Docket Number:	19-BSTD-02
Project Title:	Residential Alternative Calculation Method Variable Capacity Heat Pump Modeling Approach
TN #:	230554
Document Title:	NRDC Comments on VCHP Compliance Credit 2019-11-08
Description:	N/A
Filer:	System
Organization:	Pierre Delforge/NRDC
Submitter Role:	Public
Submission Date:	11/8/2019 2:42:50 PM
Docketed Date:	11/8/2019

Comments on Variable Capacity Heat Pump Performance Compliance Option

Docket# 19-BSTD-02

Figure 1: Monitored cooling energy savings reported in 10/16/19 CEC Staff Report on the Variable Capacity Heat Pump Performance Compliance Option

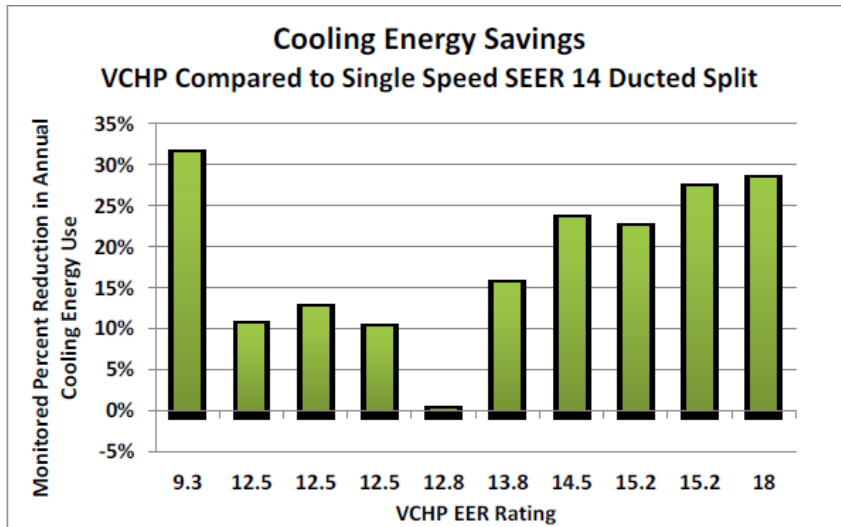
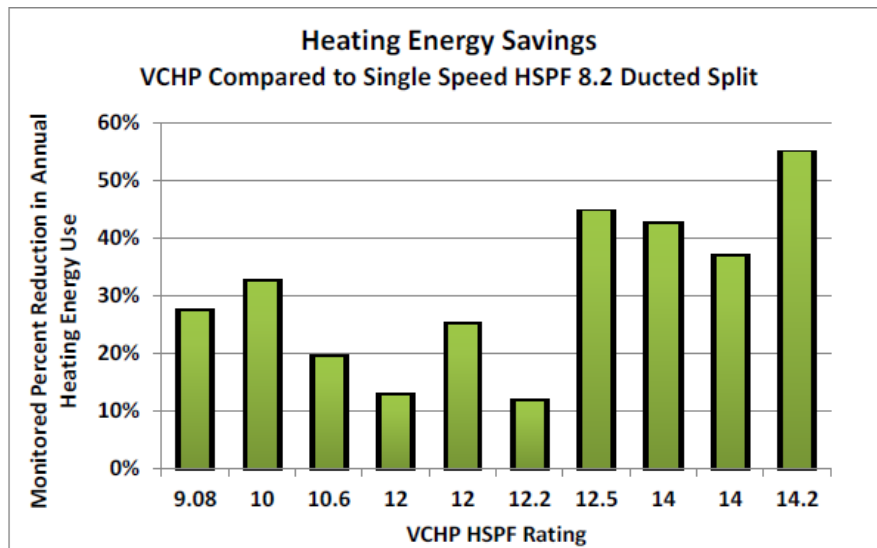
Overall, NRDC supports the VCHP credit as proposed. While the credit is conservative and would not apply to all system types, it is a step in the right direction and would grant compliance credit to ductless and low-static ducted systems. While the CEC found that energy savings did not correlate well to the SEER, EER, and HSPF ratings of the units tested, the test data did show that these systems save significant energy overall compared to a minimum efficiency single speed heat pump. As shown in Figure 1 and Figure 2, cooling savings ranged from 0 to 31%, with a mean of 18%, and heating savings ranged from 12% to 55% with a mean of 31%. The proposed credits of 5% cooling energy and 12% heating energy are low relative to these test results. They are a welcome improvement compared to the current situation, but they are far from fully valuing the energy efficiency and emissions reduction potential of VCHP products. NRDC urges the CEC to continue to improve the modeling and crediting of these systems as soon as possible.
